SUNRISE MICRO SOLUTIONS PTY. LTD.

TECHNICAL BULLETIN

To all users of Sunrise credit boards.

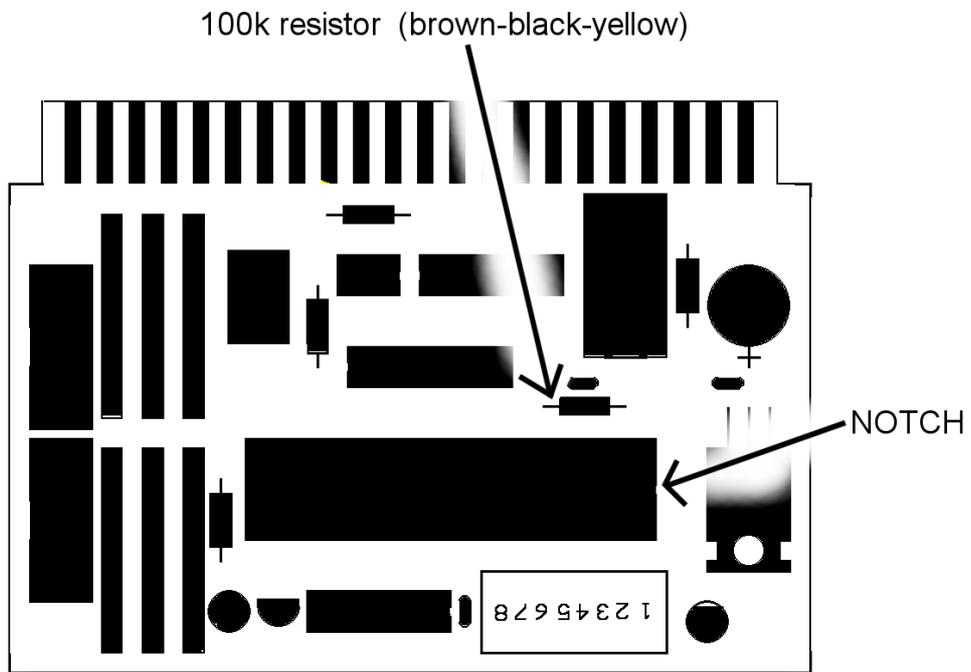
Circuit Differences.
1. The oscillator resistor , previously 15K, has been changed to 100K for the SR3. If it is ever necessary to fit a board with a replacement microcontroller IC, also change the resistor if it is not the appropriate value. If the wrong resistor is used for the SR3 part, all timed functions, (coin meter, flashing, etc) will run noticeably faster.
2. The LVI (low voltage inhibit) feature was previously controlled by the 3 terminal IC fitted fitted between the 556 timer IC and the 47mf capacitor. As the SR3 IC incorporates an internal LVI circuit, the external LVI part may be omitted on SR3 boards.

To upgrade an old style board to take the new SR3 processor the only change required is to replace the 15K ohm resistor with a 100k resistor.

100k resistor (brown-black-yellow)
